TECHNICAL
SERVICE
BULLETIN:

TS A18-1

Models Affected:
Ascape

Subject:
LP Gas Tray
Reinforcement

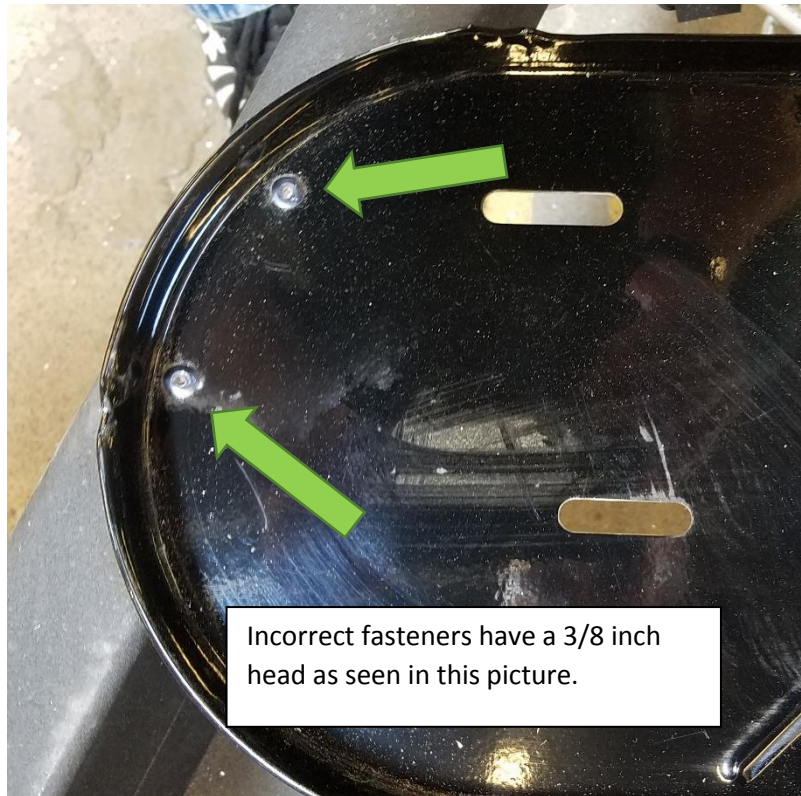
1. If smaller rivets with 3/8" head are found (as seen in picture), they must be removed by using a 3/16" drill bit.

2. Replace two smaller rivets with new 5/8" headed rivets and add two tek screws as seen in picture.
